PRESIDENTIAL
CLIMATE COMMISSION
TOWARDS A JUST TRANSITION

IRP Briefing

16th February 2024

Carbon Emissions of the Reference Pathway and Sensitivities (Mtonne)

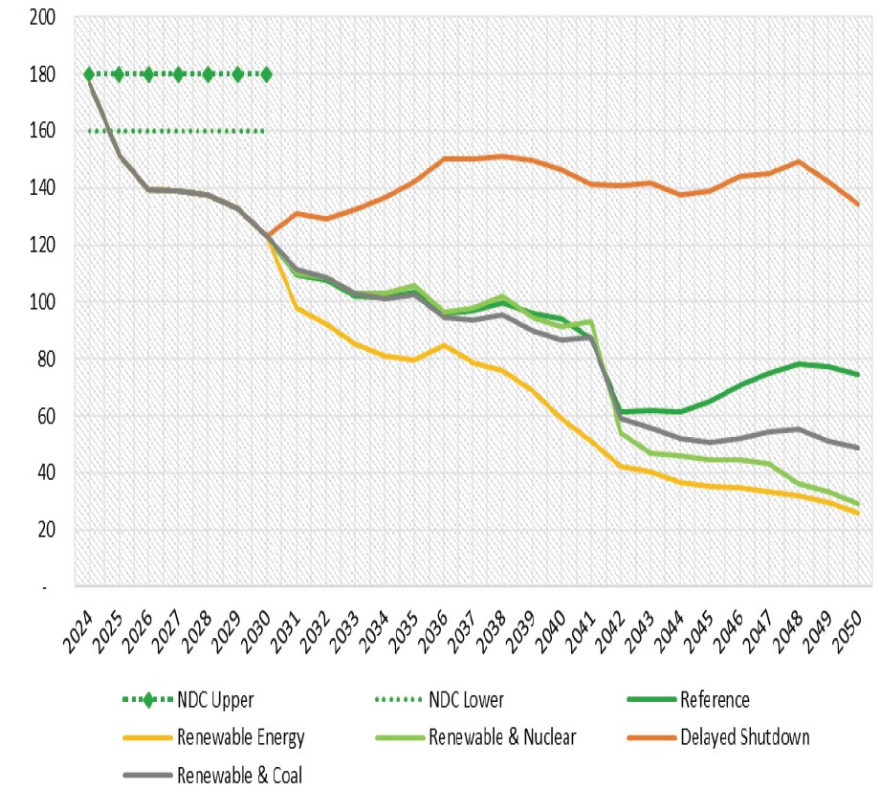
Emissions pathways need to be politically and scientifically credible and map a pathway aligned with science towards net-zero

Figure 21: Carbon Emissions Analysis for both Horizons

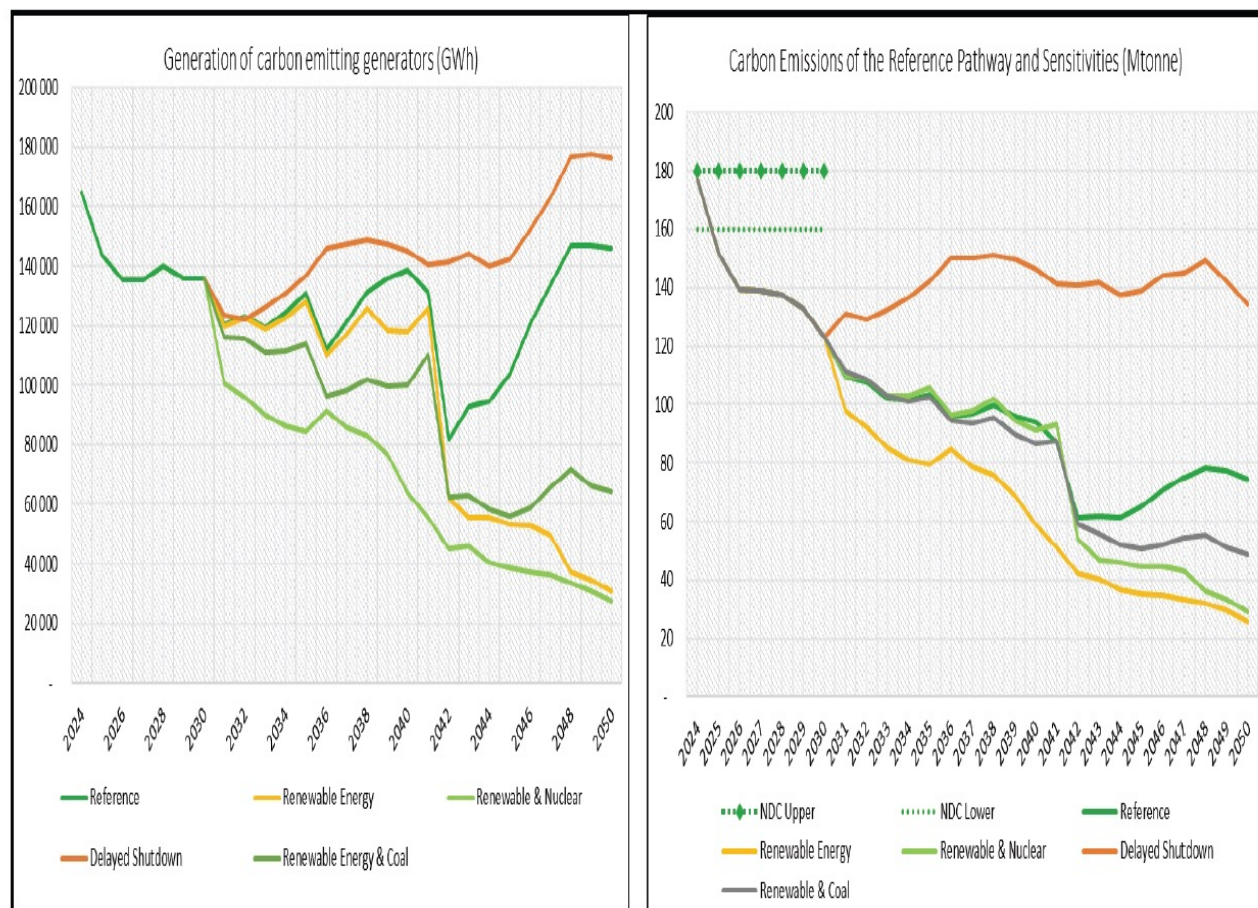
1. The starting point at the end of 2023 is 180 MT CO₂e, below modelled expectations of 185 to 190. Eskom's annual report for 2020 lists roughly 200 MT, with the difference explained by load shedding. The planned reduction of load shedding would suggest an increase in emissions, which is not reflected in the chart.

2. The reduction in GHG emissions appears disproportionate to the reduction in energy output. Figure 21 shows a reduction in roughly 23 000 GWh but 40 000 MT CO₂e. The grid GHG emissions factor published by DFFE is roughly 1 to 1. The emissions reductions seems high, and we have not been able to replicate it in modelling.

3. It is expected that the electricity will contribute a significant portion of South Africa's emissions reductions. The NDC range identified by the DMRE as 160 to 180 MT CO₂e by 2030 is different to benchmark modelled expectations.

4. The NDC range needs to be enhanced overtime. While ostensibly the DMRE modelled scenarios are below the 2030 NDC range it must be kept in mind that the NDC levels will change each 5-year period (aligned with science and the Paris Agreement and UAE Consensus).
